### Approval ID : 195967, Kingston 13 /22 , Kingston 22 /22

Please note that your application has been assessed for compliance with Evoenergy's Electricity Network and does not comply with our Electricity Networks requirements.

**GILES ST**  
**BLOCKS 13 AND 22**  
**SECTION 22**  
**KINGSTON ACT**

**EXTERNAL SERVICES**  
**SITE PLAN**

**DRAWING NUMBER**  
**ES.10**

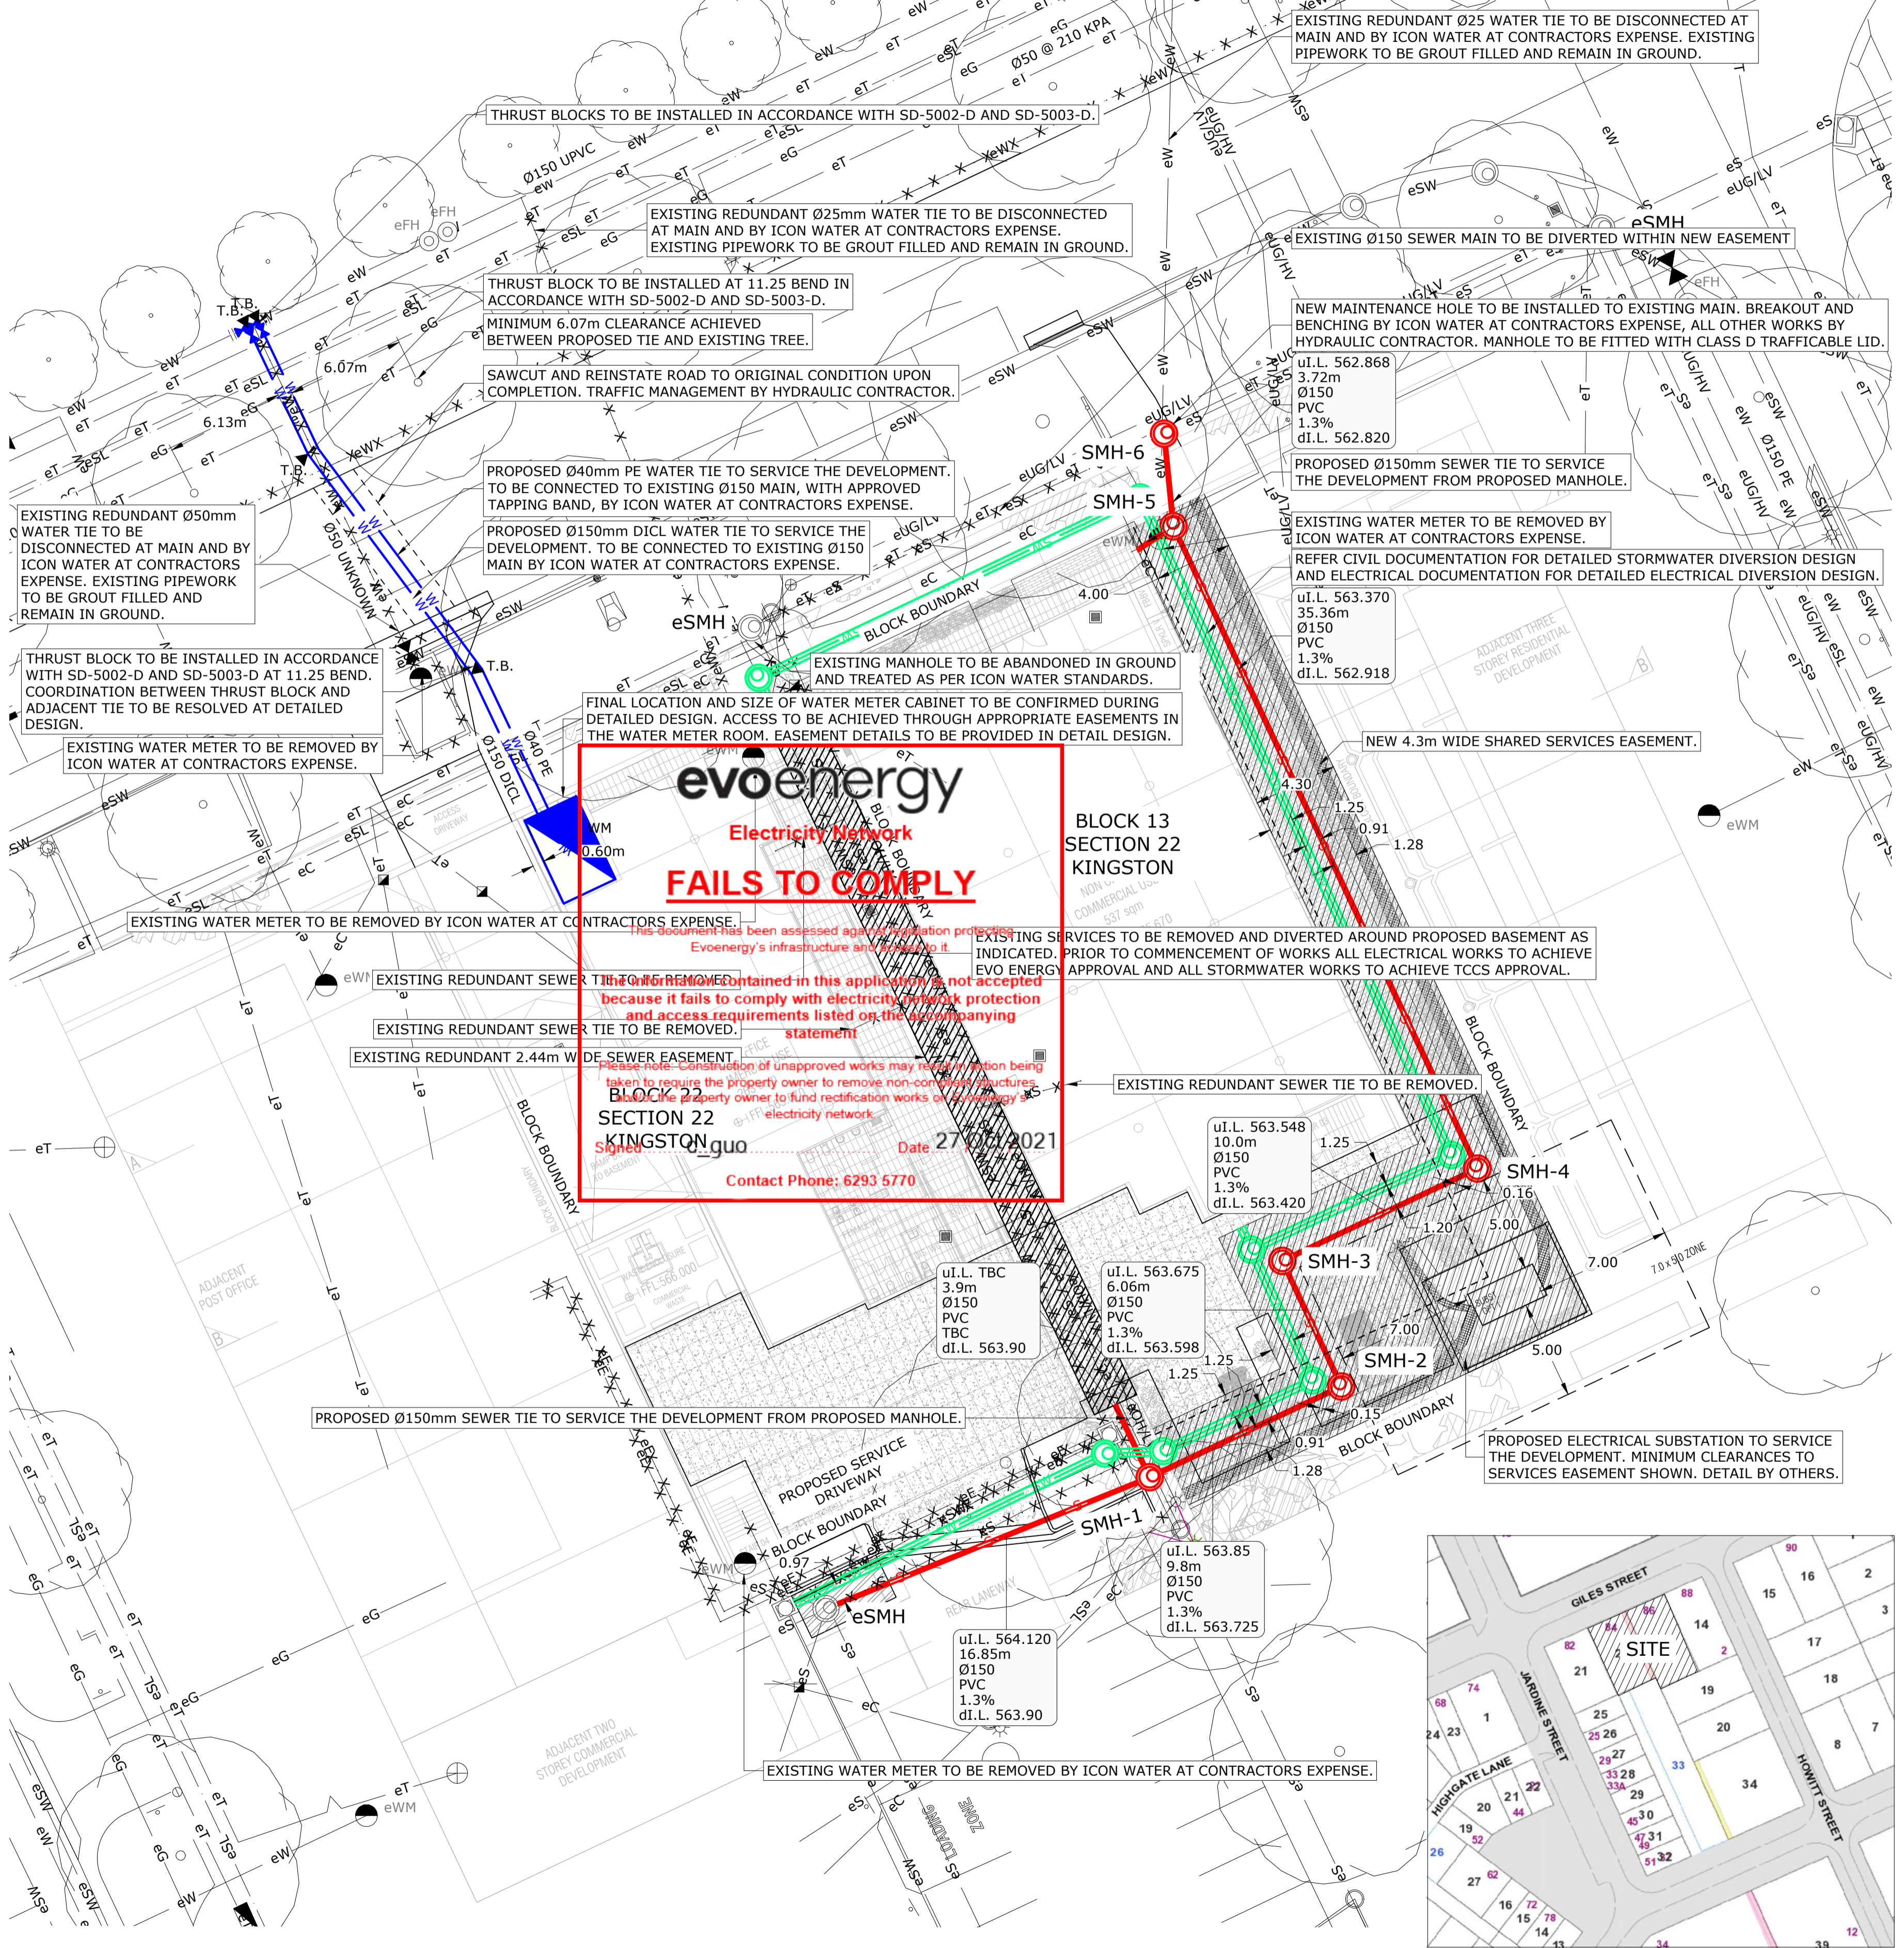
**evoenergy**  
 Electricity Network  
**FAILS TO COMPLY**

This document has been assessed against protection provisions of the Electricity Network Act 2011. Evoenergy's infrastructure and services do not comply with the requirements of the Electricity Network Act 2011.

The information contained in this application is not accepted because it fails to comply with electricity network protection and access requirements listed on the accompanying statement.

JOB REFERENCE: **VS19068**  
 DRAWING NUMBER: **C.06a**

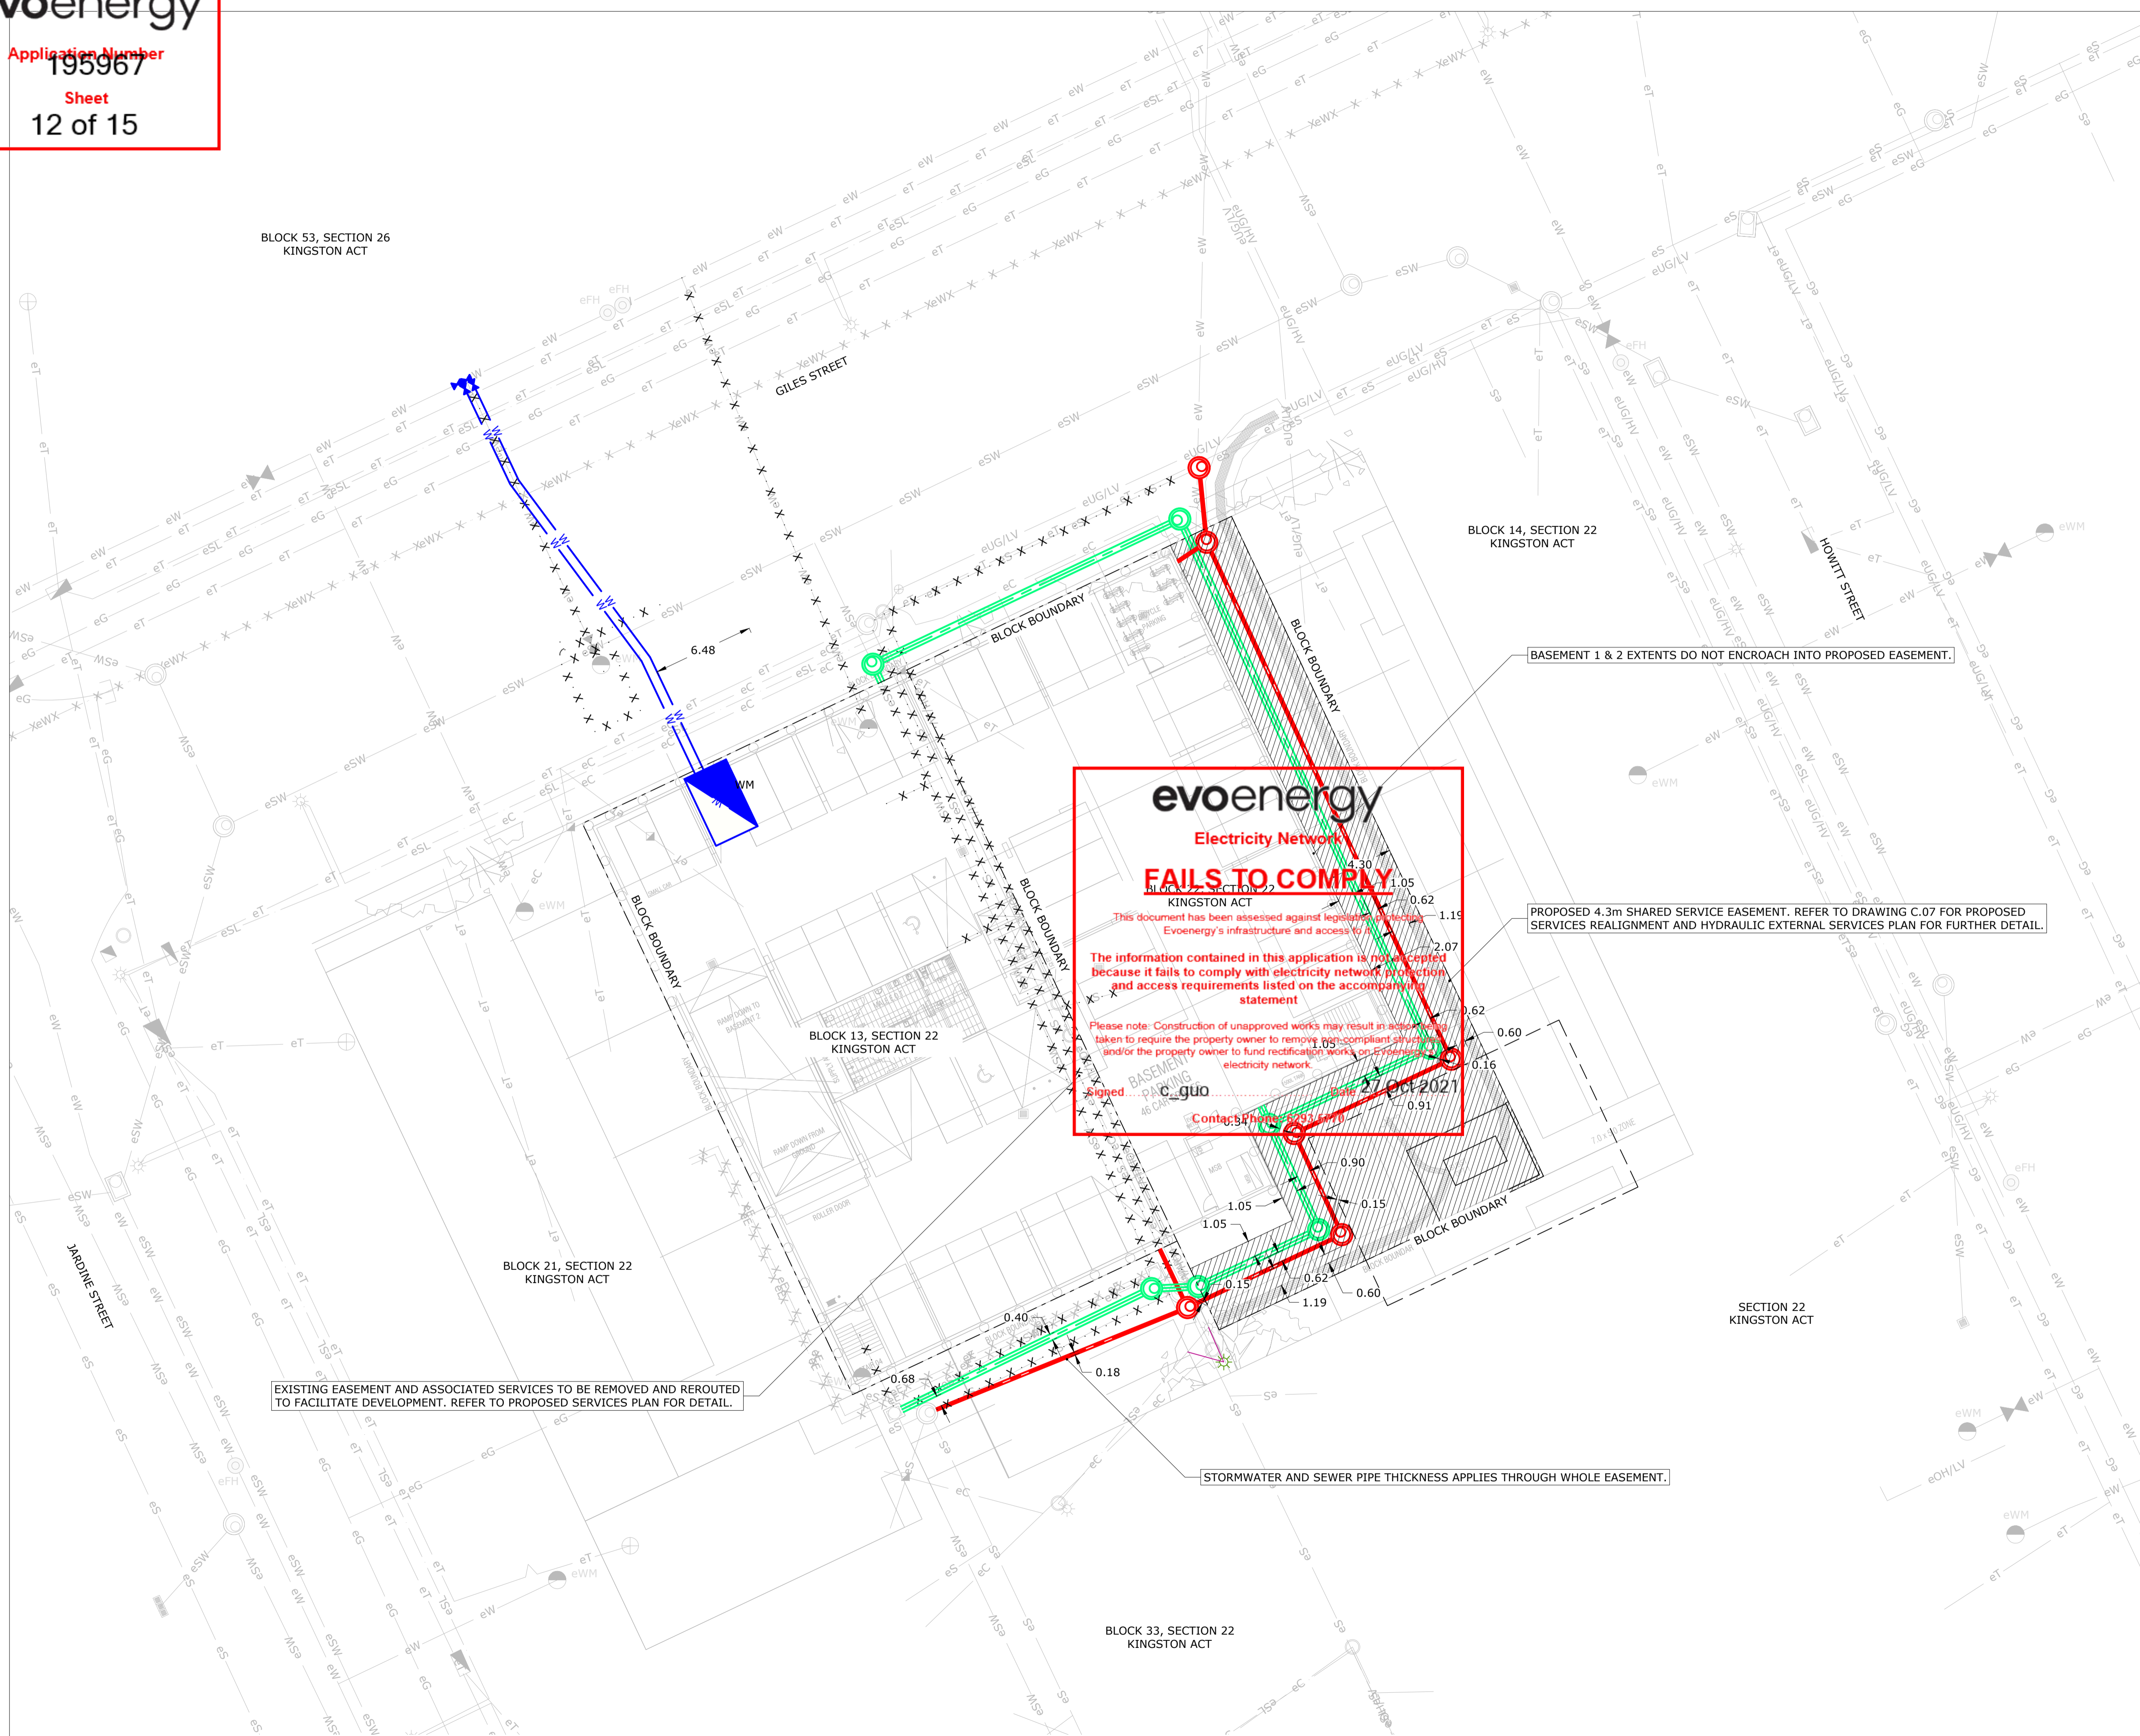
**evoenergy**  
 Electricity Network  
**FAILS TO COMPLY**  
 This document has been assessed against legislative protection of Evoenergy's infrastructure and access to it.  
 The information contained in this application is not accepted because it fails to comply with electricity network protection and access requirements listed on the accompanying statement.  
 Please note: Construction of unapproved works may result in actions being taken to require the property owner to remove non-compliant structures and/or the property owner to fund rectification works on the electricity network.  
 Signed: C. Guo Date: 27 OCT 2021  
 Contact phone: 8293 5500
